## Superseding Order by the Building Authority under section 24(1) of the Buildings Ordinance (Cap. 123) and under section 46 of the Interpretation and General Clauses Ordinance (Cap. 1)

Order No. : CBZ/TC/021920/09/NT

FLAT 6 ON 3/F ON TAI BUILDING NOS.59-67 YUEN LONG ON HING STREET YUEN LONG

Date : 24 March 2023

Plan Annexed to Order No.

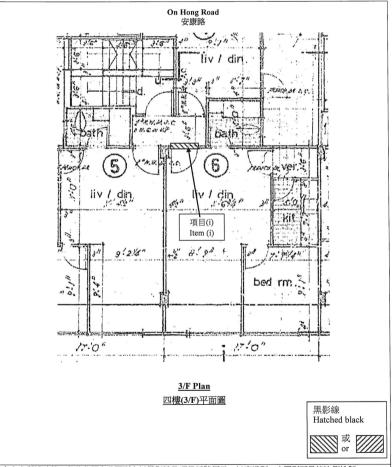
A metal gate at the entrance opening out on to common corridor.

- 2. For the said building works:
  - (a) As a result of the building works at item (i) above, Regulation 41(1) of the Building (Planning) Regulations, which requires the building to be provided with such means of escape in case of emergency as required by the intended use of the building, has been contravened.
- 3. In exercise of the powers vested in me under section 24(1) of the Buildings Ordinance, I hereby order you to:-
  - (a) demolish the said building works described under item (i) above; and
  - (b) reinstate the parts of the building so affected by the building works under item (i) above in accordance with the plans approved by the Building Authority.

4. You are required to commence the works ordered by me in paragraph 3 above within 30 days and complete such works within 60 days of the date of this order, all to the satisfaction of the Building Authority.
